ADDENDUM No. 2

Park Hill School District 2024 Sidewalk Projects

January 19, 2024

Union Chapel Elementary

Addendum #1 - Union Chapel Piers

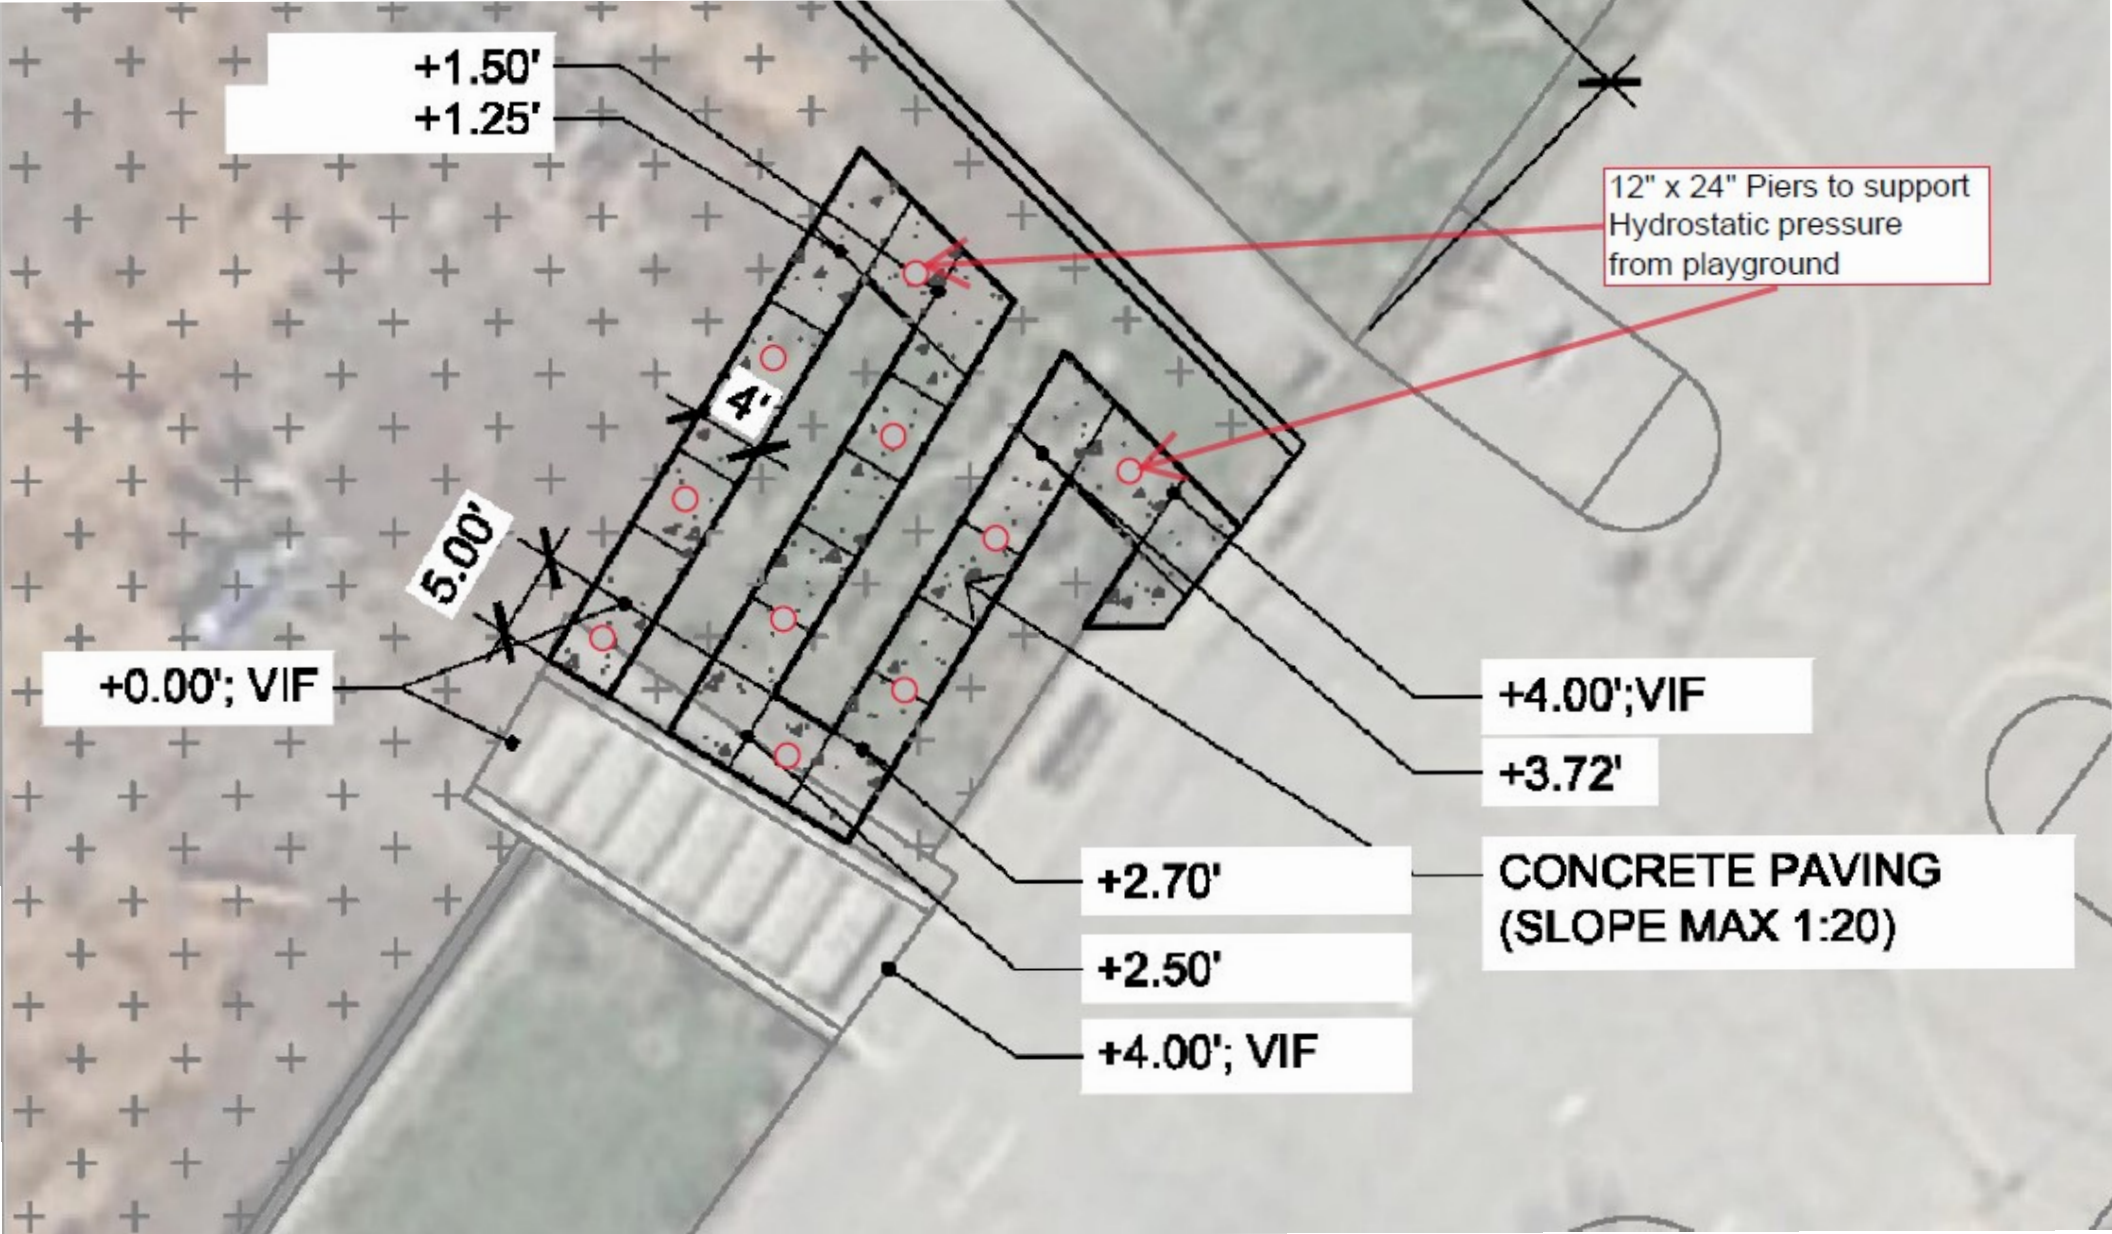
- Install 12" x 24" piers on sidewalk to support Hydrostatic Pressure from playground. Specifications included in the drawing below.
